File	CUP-1995-176									
Date_	10/6/99									
P S r c e a s n	A few items are denoted with an asterisk (*), which m ISYS retrieval system. In some instances, not all entricare also documents specific to certain files, not found of included.	es des	ign	ated to be scanned, are present in the file. There						
e n n e		بمعادمه	1	resent on the sheeklist. This index can same as a						
t d	Remaining items, (not selected for scanning), will be m	arked	ı pı	resent on the checklist. This index can serve as a						
. "	quick guide for the contents of each file.									
	Files denoted with (**) are to be located using the ISYS									
	in full, as well as other entries such as Ordinances, Reso	lutior	ıs, I	Board of Appeals, and etc.						
X X	J									
X X	- Application 101111									
XX	Receipts for fees paid for anything									
XX	*Submittal checklist									
XX	*General project report									
+	Reduced copy of final plans or drawings

Analysis of the Conoco Products Loading Terminal Site Plan and Proposed Modifications

RE: Response to Review Comments - File #VR-95-176

Response To Preliminary Permit Review Comments

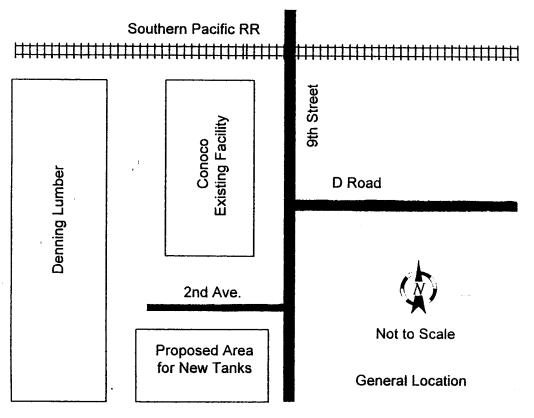
The proposed on-site circulation is a special concern as 2nd Avenue is a city owned street that currently provides access to Denning Lumber, a supplier of building material. The on-site circulation plan proposed by Conoco, Inc. requires that 2nd Avenue become a staging area for gasoline trucks waiting to be loaded. Furthermore, the staging area is located on the south side of the street and gasoline trucks are supposed to be parked in the opposite direction of normal traffic flow. This allows gasoline trucks, normally 70 feet in length, to make the turn into the loading area. Conoco has submitted two optional designs to correct the on-site circulation problems, but each option requires the new storage tanks to be located in the street right-of-way.

Specifically, the review conducted by Aldridge Transportation Consultants (ATC) of the proposed modifications to the Conoco Products Loading Terminal has determined that:

- 1) Approving an atypical and potentially dangerous traffic situation on city property could expose the City to possible lawsuits should an accident occur.

- 2) The on-site circulation plan proposed by Conoco, Inc. impedes full use of a public street access to Denning Lumber. The options presented by Conoco put the new storage tanks into the street right-of-way which is unacceptable unless the City wishes to vacate the street.

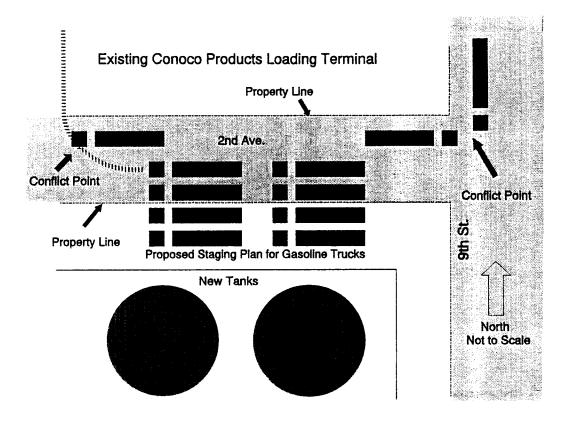
The preferred circulation plan submitted by Conoco shows gasoline trucks parked facing west in the eastbound lane of 2nd Ave. This is done so that the gasoline trucks, typically 70 feet in length, have sufficient room to turn into the property and the loading area. The turn from this location could cause a broadside type accident with a westbound vehicle going into Denning Lumber. Furthermore, it could cause an awkward situation entering and exiting 2nd Ave. to and from 9th Street. The bottom line, however, is liability regarding the City sanctioning an improper use of city streets. There may be an exposure for the City that is unacceptable. Options submitted by Conoco show the new storage tanks in City right-of-way, which is unacceptable unless the City wishes to vacate 2nd Avenue.

The following graphic shows the proposed circulation plan and potential conflict points.
